Access Report

**New Stables Complex**  
**Newcastle Jockey Club**  
Cnr Chatham & Darlings Streets  
BROADMEADOW NSW

For: Newcastle Jockey Club  
Ref: LP\_21369

Development application documentation for the New Stables Complex Development at the Newcastle Jockey Club, located at the corner of Chatham & Darling Street Broadmeadow, has been reviewed against current accessibility legislation.

Figure 2 | Overall Site Plan

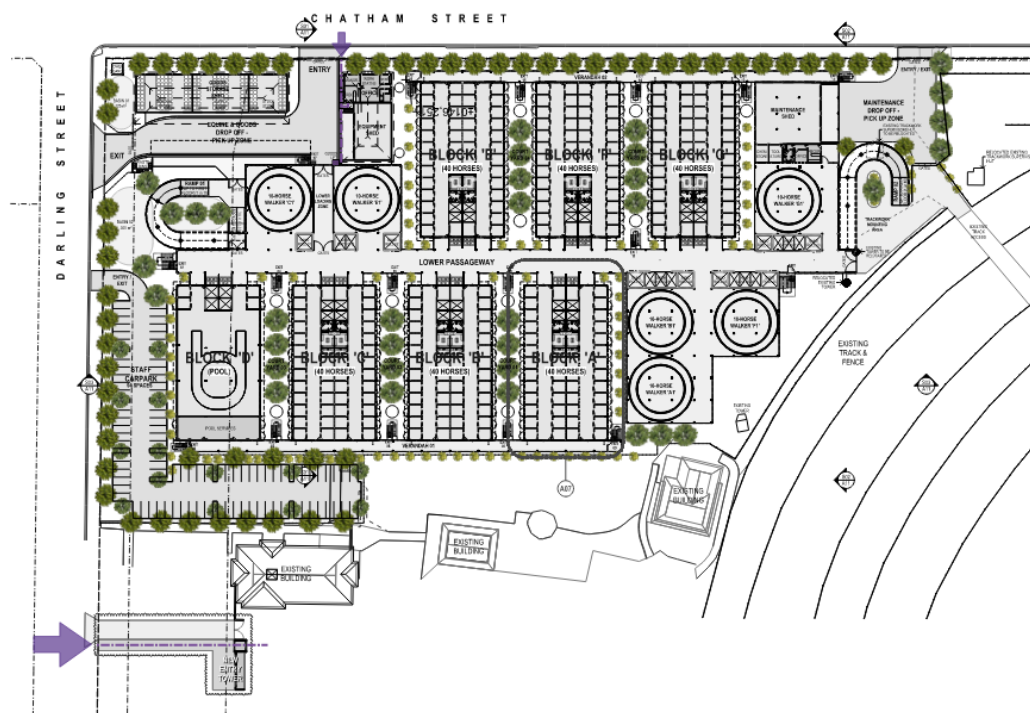
The location of accessible carparking areas is not indicated in the site plan. However, the path of travel from the car parking areas and the Office Building is conducive to an accessible path of travel.

The location of accessible car parking is not indicated on the site plan. Carparking areas are generally level and conducive to the provision of designated accessible car parking.
